**World Forum for Harmonization of Vehicle Regulations****Working Party on Automated/Autonomous and Connected Vehicles\*****Fourth session**

**UN Regulation No. 90****Proposal for Supplement 5 to the 02 Series  
of Amendments to UN Regulation No. 90  
(Replacement brake linings, pads, disks and drums)****Submitted by the expert from Russian Federation\*\***

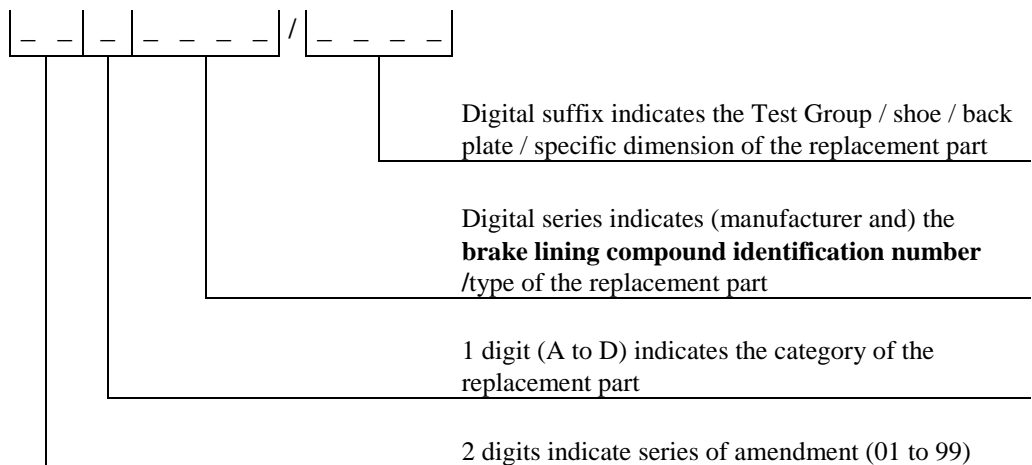
- 4.1. ...
- 4.1.1. ...
- 4.2. To each replacement part approved there shall be assigned an approval **code and an approval number, the latter in the format according to Schedule 4 to the Revision 3 of the 1958 Agreement. The approval code shall comprise ~~comprising~~ four groups of digits:**
  - 4.2.1. ...
  - 4.2.2. ...
  - 4.2.3. The next series of digits shall indicate the manufacture and the ~~type~~ **brake lining compound identification number** of the brake lining, the type of disc or the type of drum.  
 The digital suffix shall indicate:
    - (a) The shoe or back plate or specific dimension in the case of drum brake linings;
    - (b) The Test Group in the case of a replacement disc or replacement drum.
 The variants approved as a Test Group shall be listed as an appendix to the communication document:
